Subdivision Authority

File No. LDA07-0353

RE: Tentative plan of subdivision to create 50 Semi-detached residential lots and 24 Single Detached Residential lots from portion of Lots 4, 5 and 14, Block 2, Plan 6215V, located south of 160 Avenue, north of 157 Avenue and east of 97 Street alignment; **EAUX CLAIRES**

SUBDIVISION CONDITIONS OF APPROVAL MAP

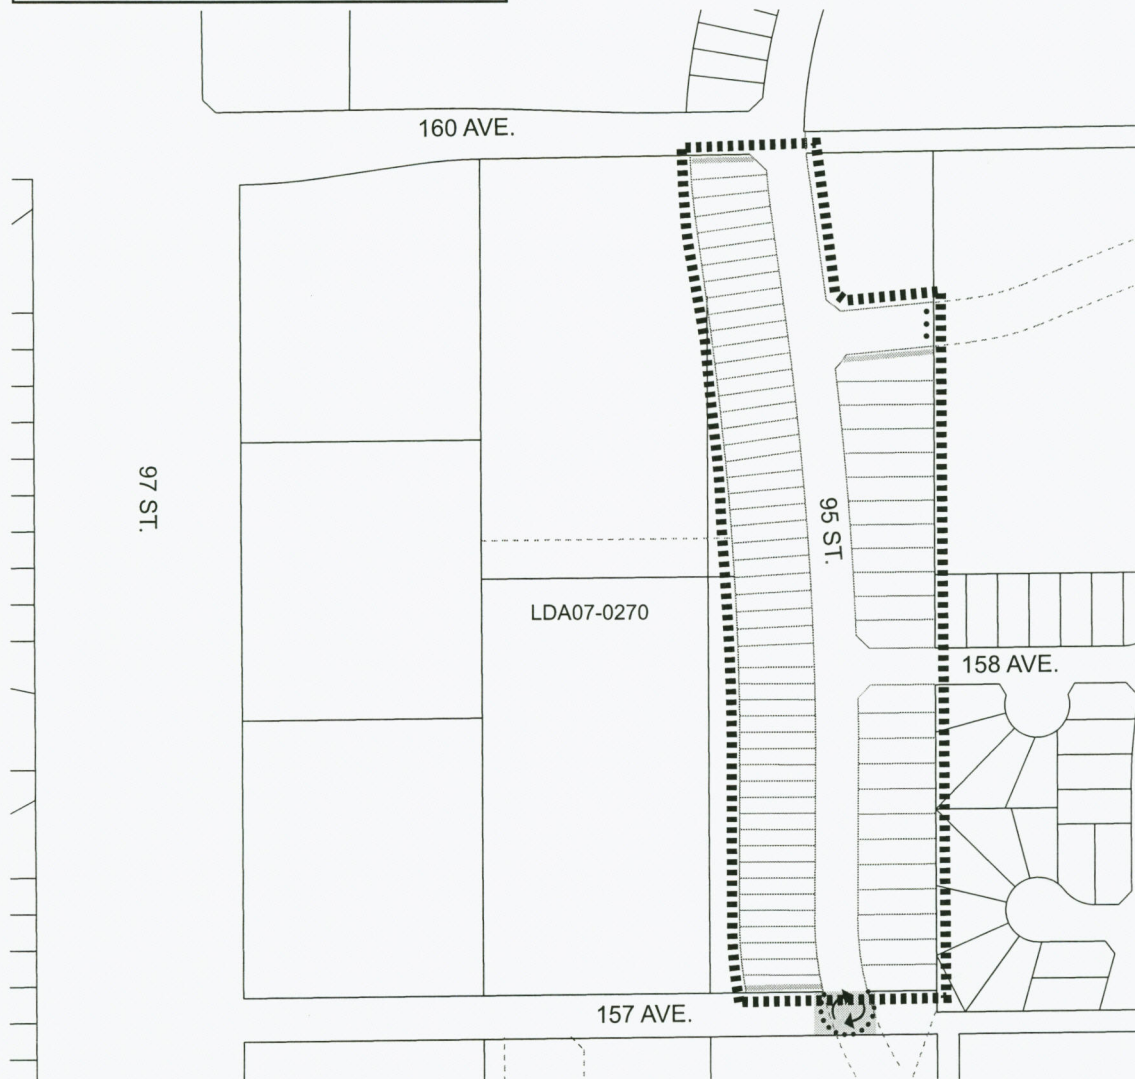
5. that the Engineering Drawings include construction of a temporary turnaround with bollards, as shown on the "Conditions of Approval" map, Enclosure I, to the satisfaction of the Transportation Department;

8. that the owner construct fencing, in the locations shown on the "Conditions of Approval" Map, Enclosure I, to the satisfaction of the Parks Branch of the Asset Management and Public Works and Transportation Departments.
